DESIGN <i>PH</i>	DRAWN BY <i>PH</i>	DART AEROSPACE LTD HAWKESBURY, ONTARIO, CANADA	
CHECKED <i>[Signature]</i>	APPROVED <i>[Signature]</i>	DRAWING NO. DSI 9346	REV. A SHEET 1 OF 1
DATE 06.08.08		TITLE DEVIATION ON D206-667	SCALE NTS
A	06.08.08	NEW ISSUE

DART SERVICE INSTRUCTION

TO AMEND INSTALLATION INSTRUCTIONS IIN-D206-667 REV. C
REF. CANADIAN STC: SH01-5
REF. FAA STC: SR01304NY

FIGURE 1 – INSTALLATION OF DART CROSSTUBES ON BHT/AAI SKIDTUBE

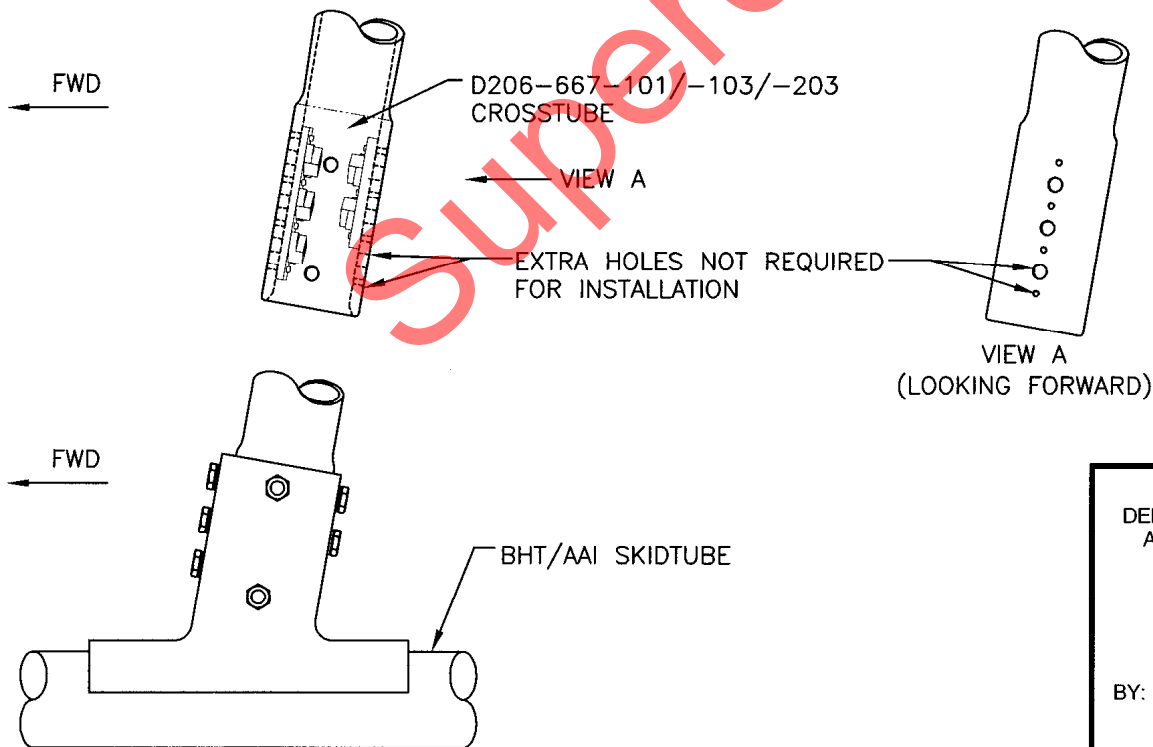
THE FOLLOWING D206-667-101/-103/-203 CROSSTUBES HAVE EXTRA HOLES DRILLED ON THE AFT SIDE OF THE CUFFS. THIS HOLE IS NOT REQUIRED FOR INSTALLATION OF DART CROSSTUBES ONTO BHT/AAI SKIDTUBES AS SHOWN IN FIGURE 1.

CUSTOMERS RECEIVING CROSSTUBES AT CHG 002 PRIOR TO 06.08.08 SHOULD CONTACT DART FOR DISPOSITION IF INSTALLING THE DART CROSSTUBES ONTO BHT/AAI SKIDTUBES PER IIN-D206-667 REV. C.

CUSTOMERS RECEIVING CROSSTUBES AT CHG 002 PRIOR TO 06.08.08 TO BE INSTALLED WITH DART SKIDTUBES MAY FIND THAT THE SUPPORTS HAVE BEEN INSTALLED BACKWARDS. THE SUPPORTS SHOULD BE REMOVED AND RE-INSTALLED PER ICA-D206-667.
